**Approval no: DEV2017/864**

### **CARSELDINE URBAN VILLAGE - STAGE S RESPONSE TO FURTHER ISSUES - TRAFFIC MATTERS**

CARSELDINE URBAN VILLAGE -  
STAGE S

Carseldine Urban Village Proposed Stage S Layout			
Drawn T.Anang	Date 19/03/2018	Scale 1:500	Size A3
Drawing Number CEB06857 - SK15			Revision B

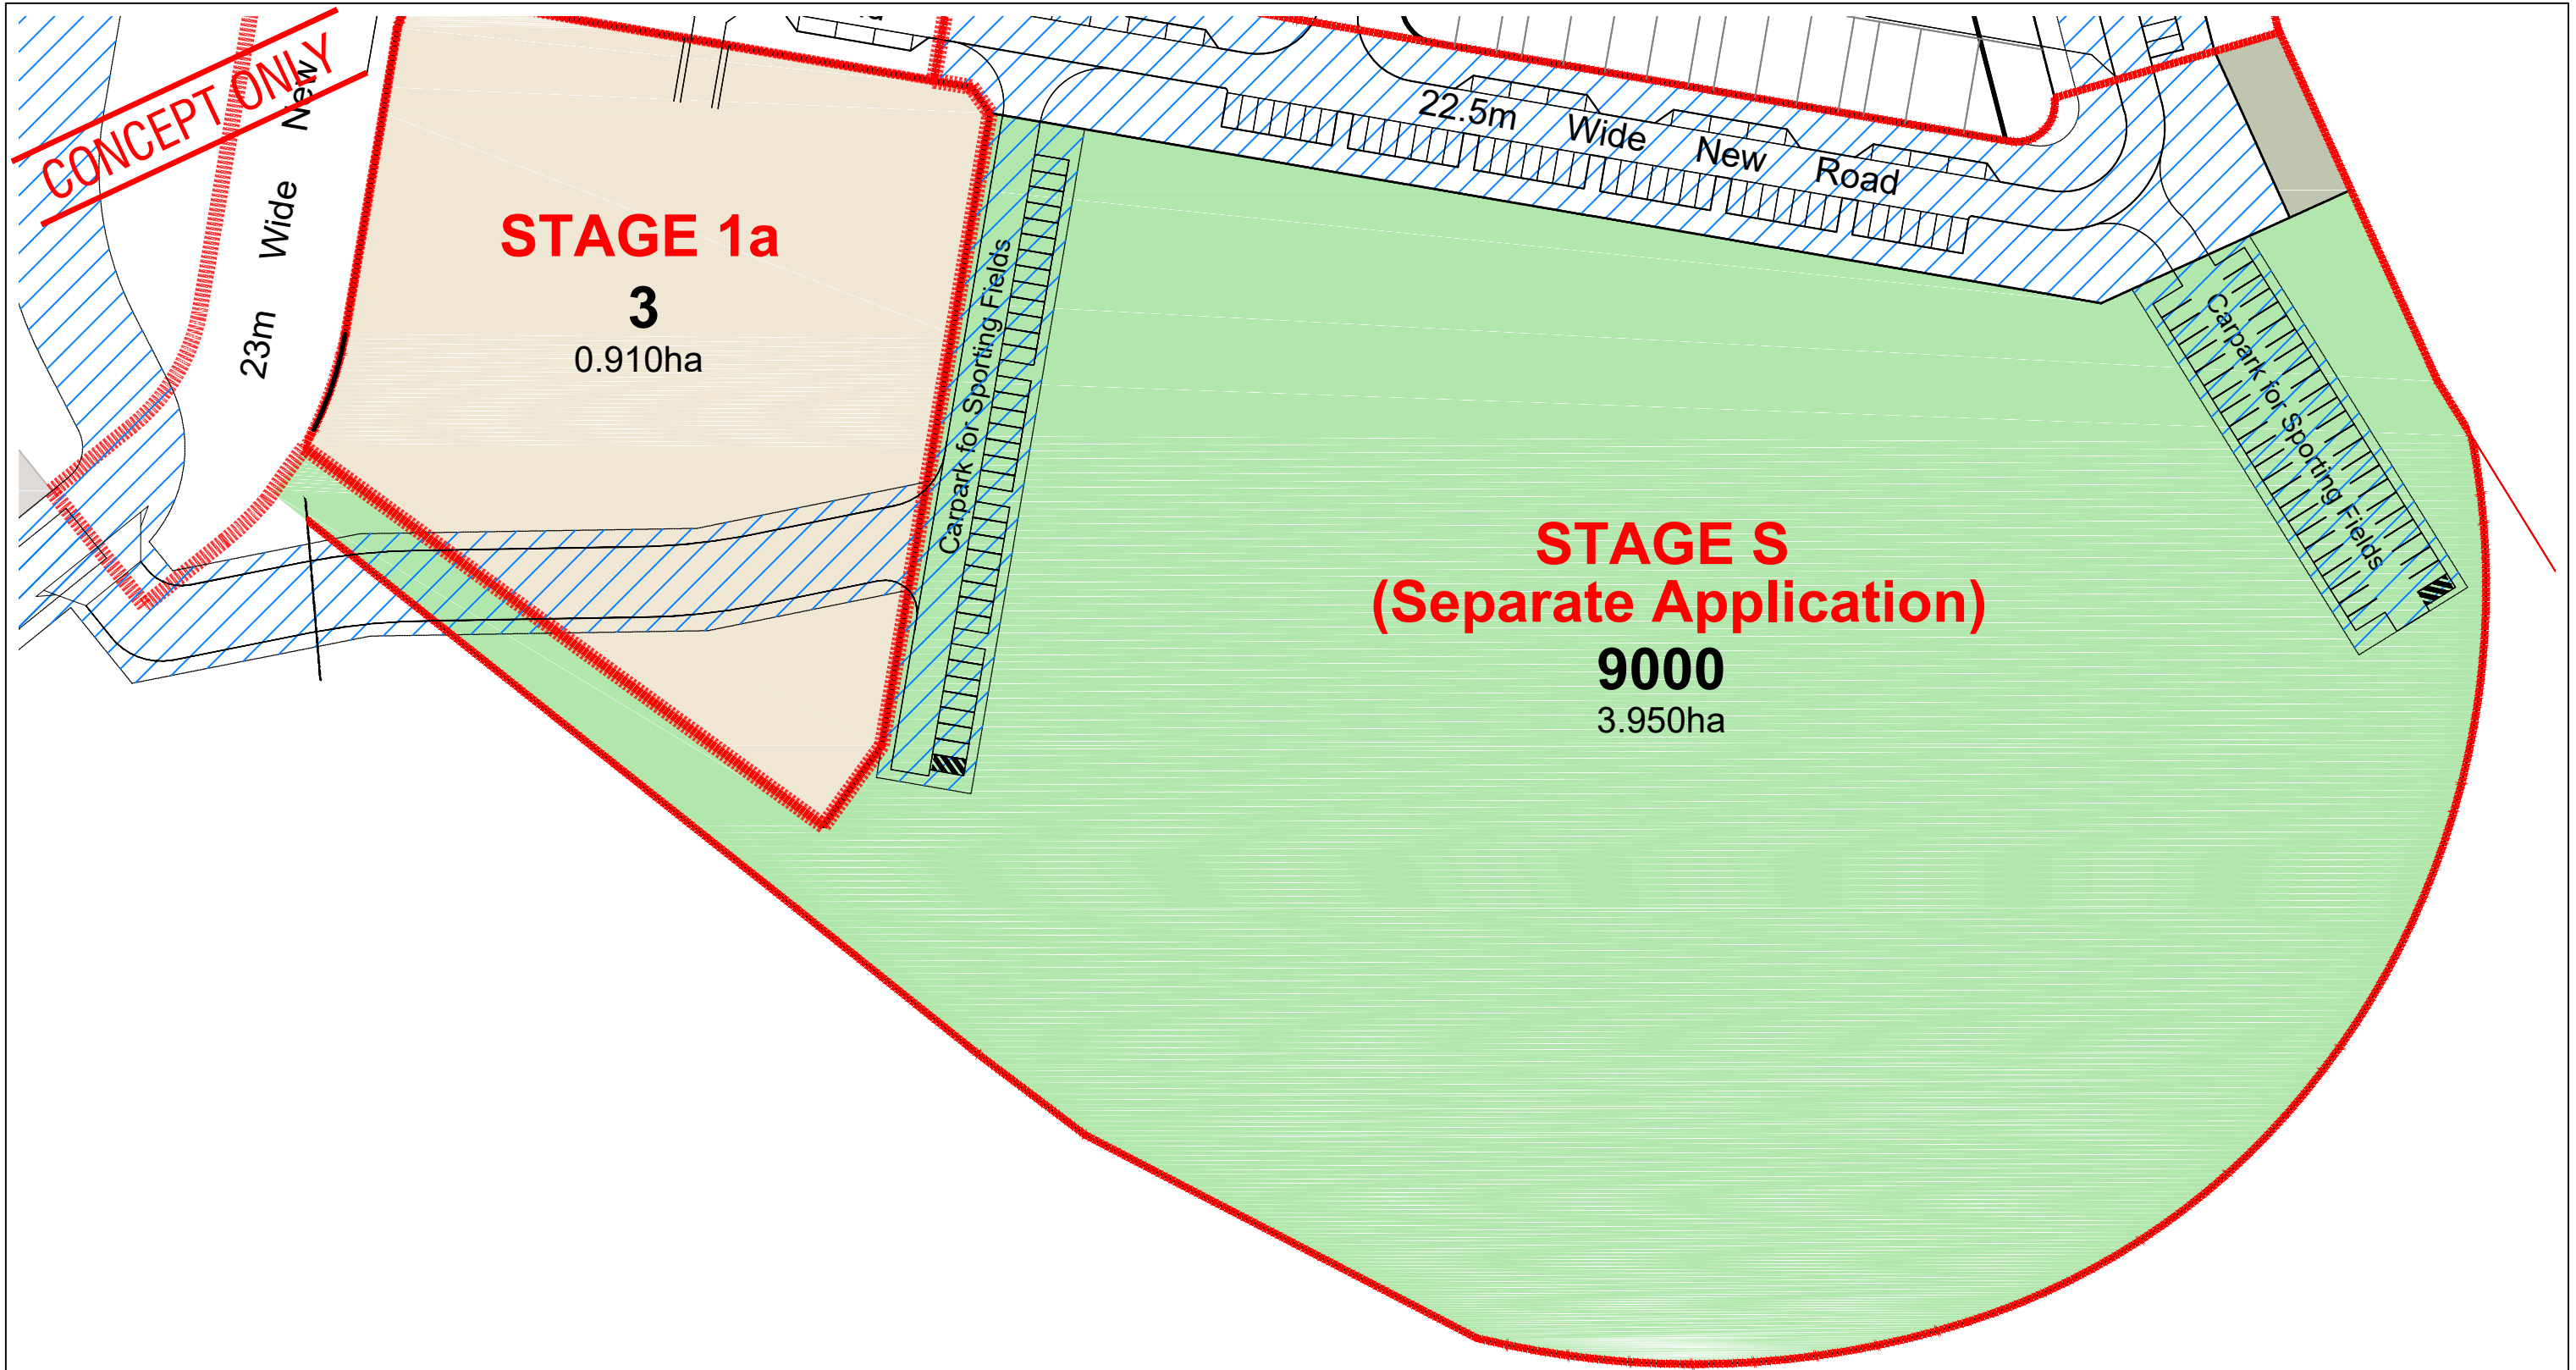
Access to the proposed CUV development for Stage S will be primarily through the existing Beams Road access. This access is an unsignalised intersection providing all movements for traffic ingress and egress. The access location is within 100m walking distance of the closest bus stops. As this is an existing access, the proposal is not deemed to compromise the safety of the existing road network. Furthermore, a temporary access road will connect the access easement to the car parking area until further stages are completed as illustrated in drawing CEB06857-SK15-B.

<b>Carseldine Urban Village</b>			
Safe Intersection Sight Distance Review			
Proposed Stage S Access Intersection			
50km/hr Design Speed			
Drawn	Date	Scale	Size
T.Anang	08/02/2017	1:500	A3
Drawing Number			Revision
CEB06857 - SK13			A

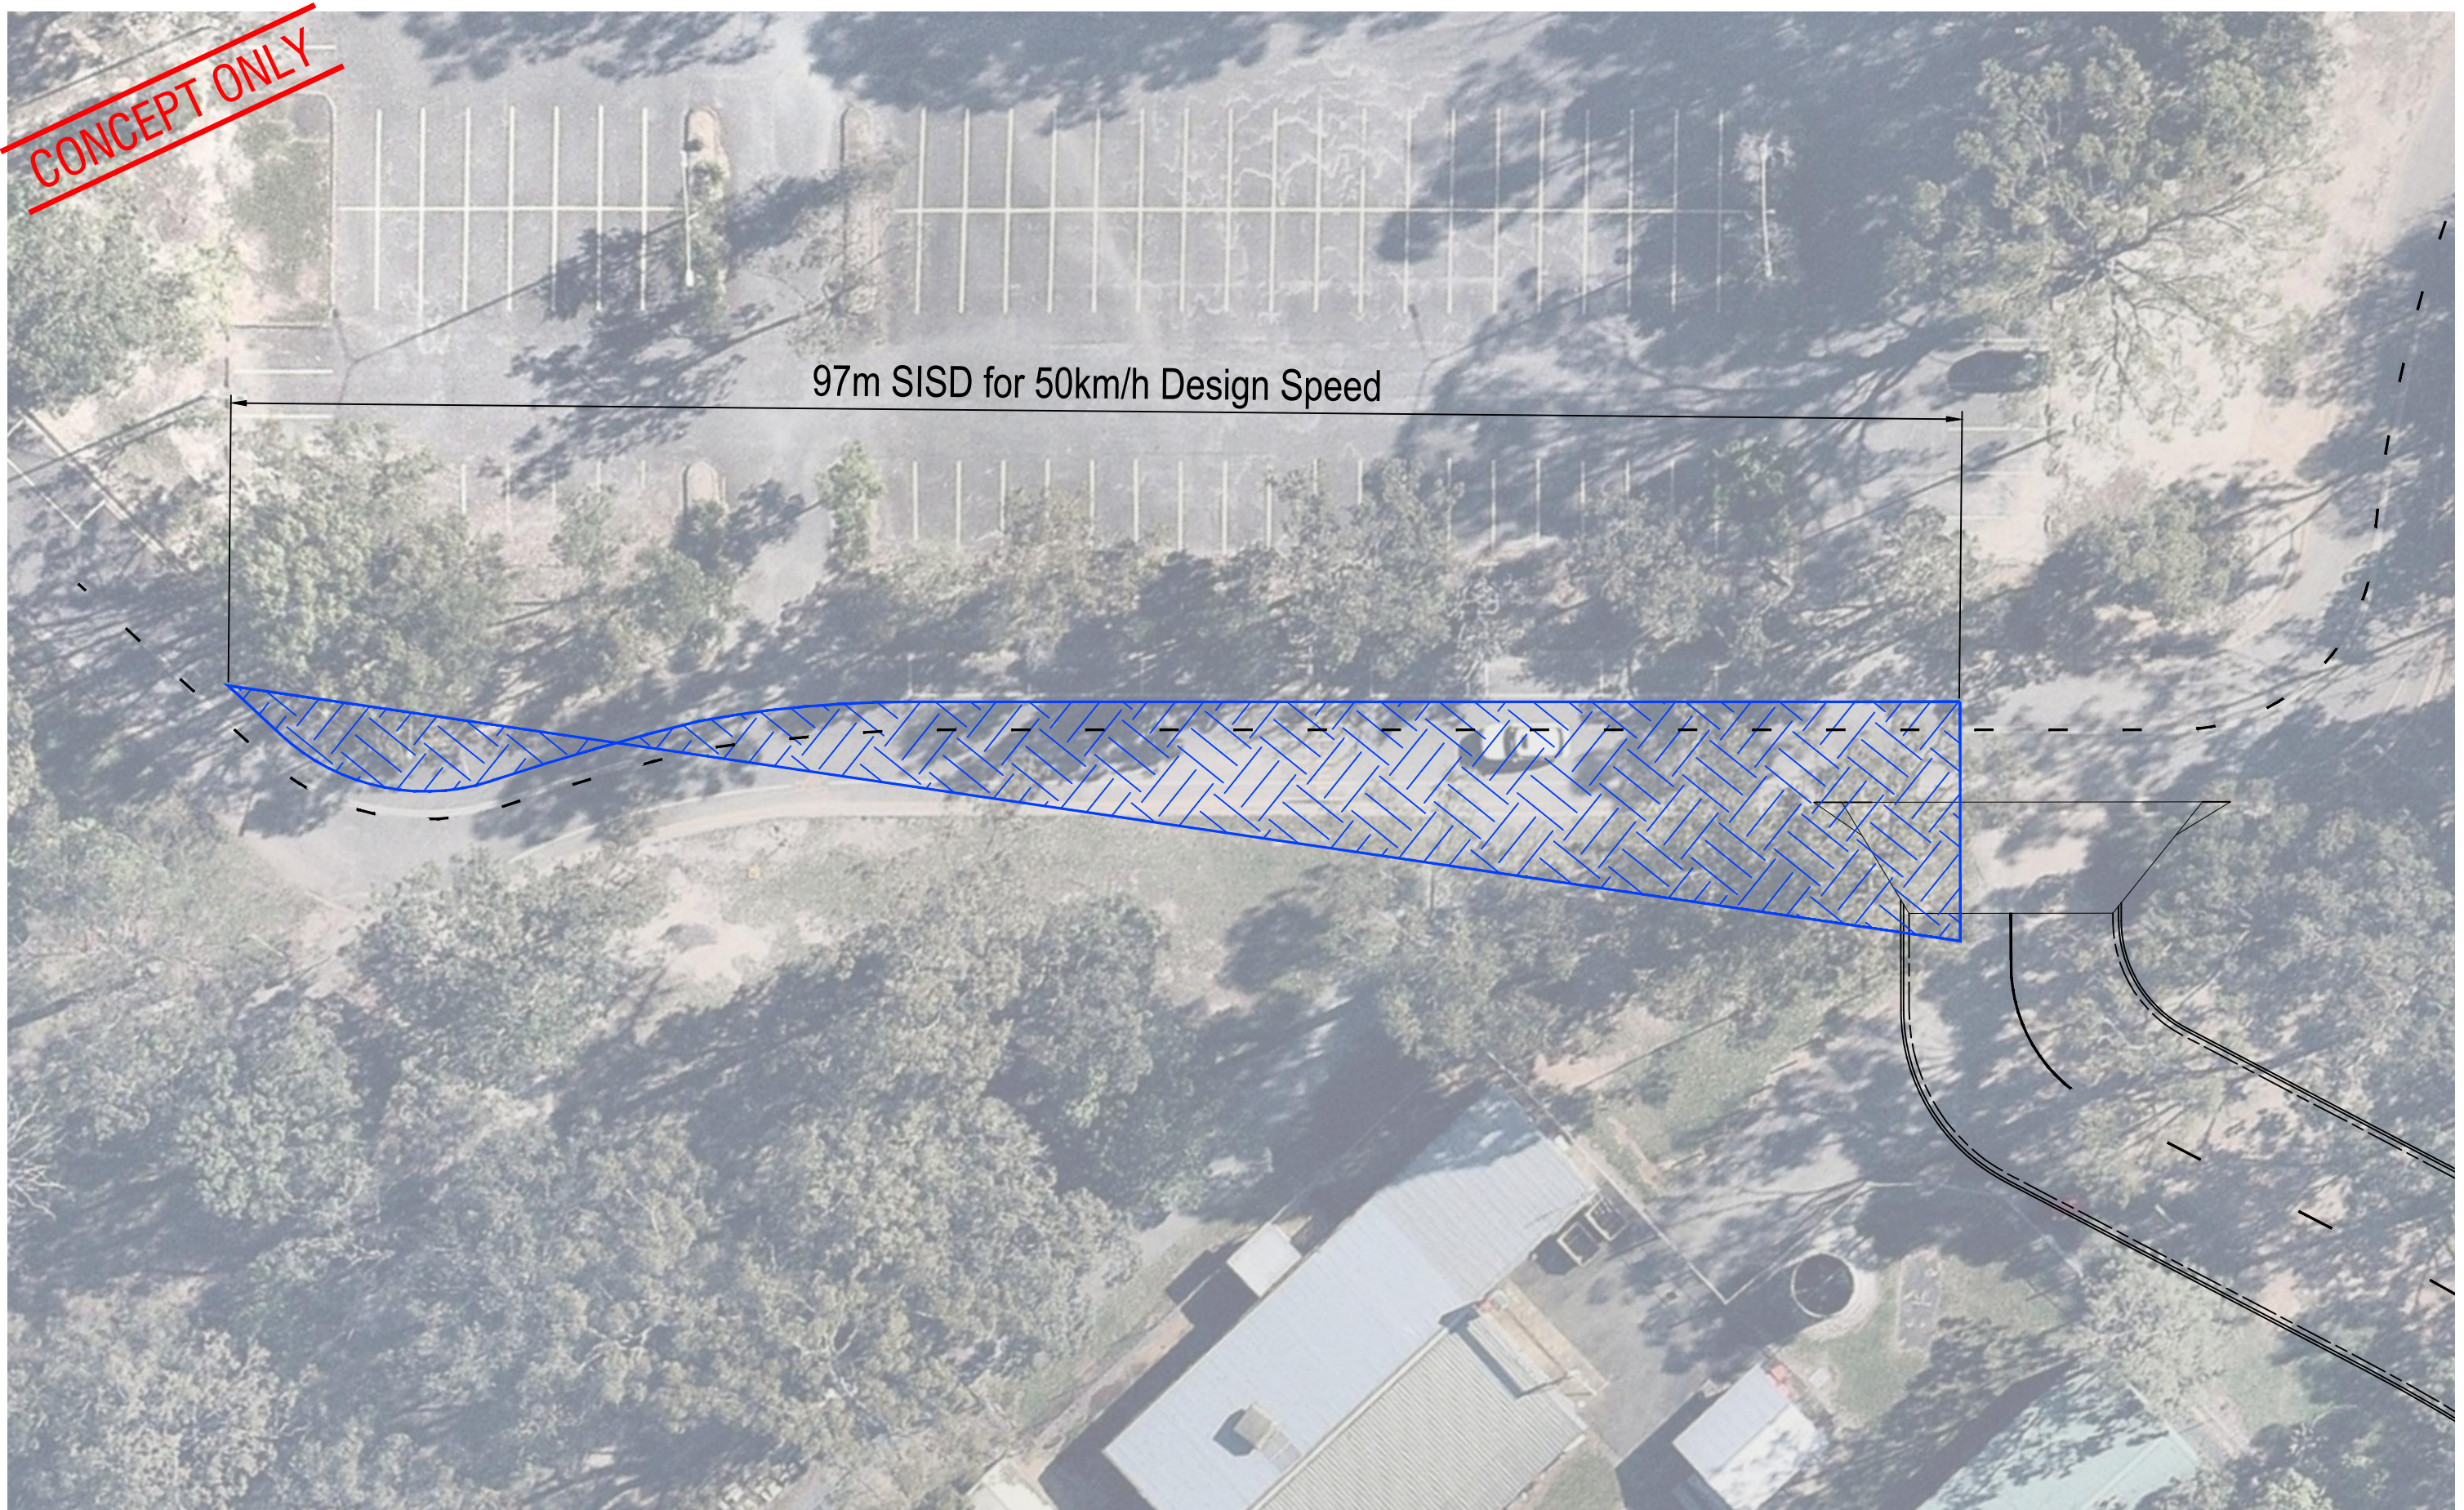
*Safe Intersection Sight Distance*

Based on these parameters, it is determined that the safe intersection sight distance is 97m.

The sight distance drawings CEB06857-SK12-A and CEB06857-SK13-A demonstrate that sufficient sight distance (in excess of 97m) is provided at the proposed temporary access. Similar to Figure 1-2, vegetation maintenance is required for the overgrown bushes on the eastern verge of the road to maintain clear sight lines.
